The Land Art Generator Initiative 2012 Design Competition for Freshkills Park, NYC.

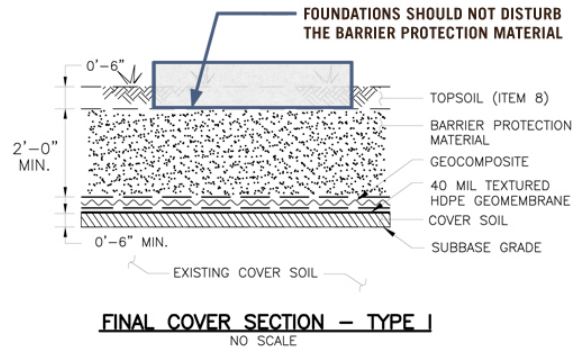
18. Q: Can the artwork be located on the water? If yes, what are the requirements?

A: Yes, as long as the artwork remains within the project boundaries (there is a small area of the project site that crosses over Main Creek). The requirements are the same as for artwork located on land. We would like to stress that submissions should be respectful of the natural ecosystem and the safe use of the park. The water of Main Creek is used recreationally for kayaking and is home to birds, tortoises, fish and other wildlife.

Additional response from New York City Department of Sanitation:

There are also New York State regulations that will need to be factored in with respect to Tidal wetlands, Freshwater wetlands, stormwater basins and stormwater discharges to the creeks. This link will direct participating design teams to the NYSDEC (Division of Water) website:

Hatched areas are outside the SWMU boundary but also inside the LAGI plot boundary

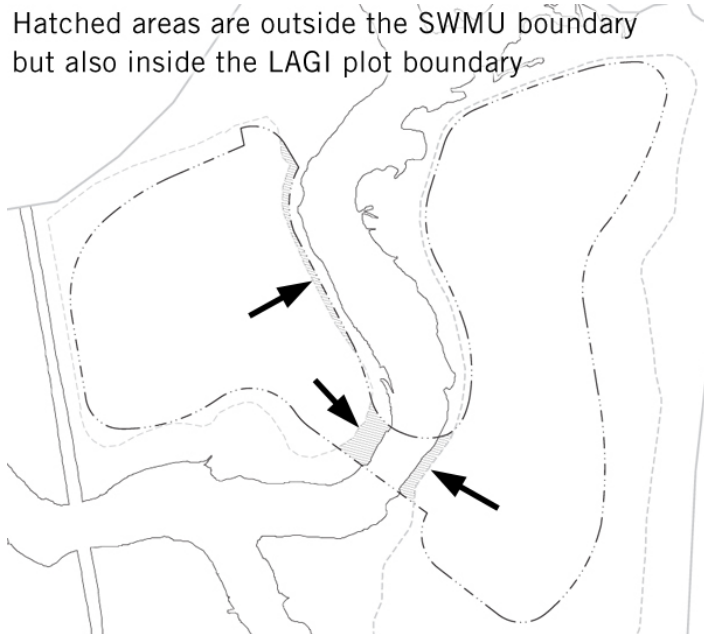
25. Q: What is the soil composition and bearing capacity outside the solid waste boundary and at what distance is it to solid rock?

A: There are limited areas in which the 2012 plot boundary extends beyond the landfill cap leachate liner (SWMU boundary). We have created a new drawing that is available for download at <http://landartgenerator.org/designcomp/> in the Supplemental Downloads section under the names "BoundaryLimitOverlay.pdf" and "BoundaryLimitOverlay.dwg":

In this new drawing you will see these limited areas with a cross hatch. Care should be given in these areas to respect the Right of Ways of existing and planned roads. Because there is no landfill cap in these areas, the restrictions discussed in Question #19 do not apply.

You need to not only be aware of the SWMU boundary, but also any leachate/monitoring wells/etc. in these areas. For example, looking at the drawings provided, Basin E is in this area of 3/4 as are the leachate collection drain, force main, and groundwater monitoring wells.

Also, once you go outside (or "outboard") of the leachate collection drain, you will have to deal with tidal wetland and adjacent area permits and, probably, constructability issues.

Specific geotechnical data and distance to bedrock is not available at this time.
